# 1977 Corvette: Service Bulletin: Anti-Theft Alarm System Interim Modifications

**Model and Year:** 1977 Corvette

**Bulletin No:** 77-I-38

**Date:** May 1977

FIGURE 1

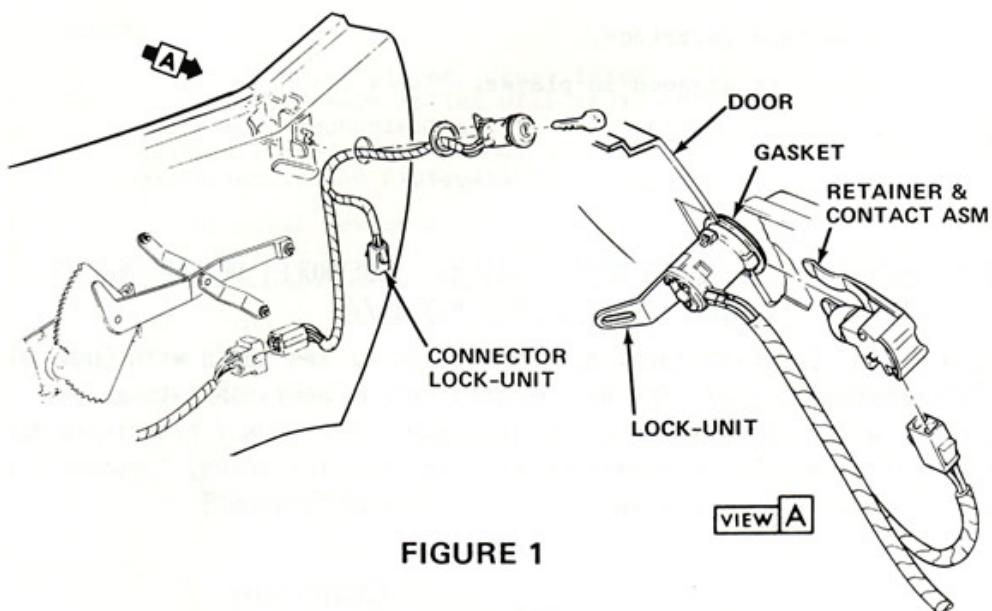
- The actuating switch for the system is no longer located on the left front fender. It has been incorporated into the left front door lock and must be activated by locking this door with the key from outside of the vehicle (Figure 1). This is the only way the alarm can be set. Turning the inside door knob to the locked position when exiting the vehicle will not activate the alarm system.
- The anti-theft alarm system horn has been moved from the left rear inner fender to the far left side of the engine compartment dash panel. (Figure 2).
- The anti-theft alarm system flasher assembly is now located on the console trim plate (Figure 3), rather than the rear compartment underbody panel.
- The new anti-theft alarm system wiring diagram is illustrated in Figure 4.
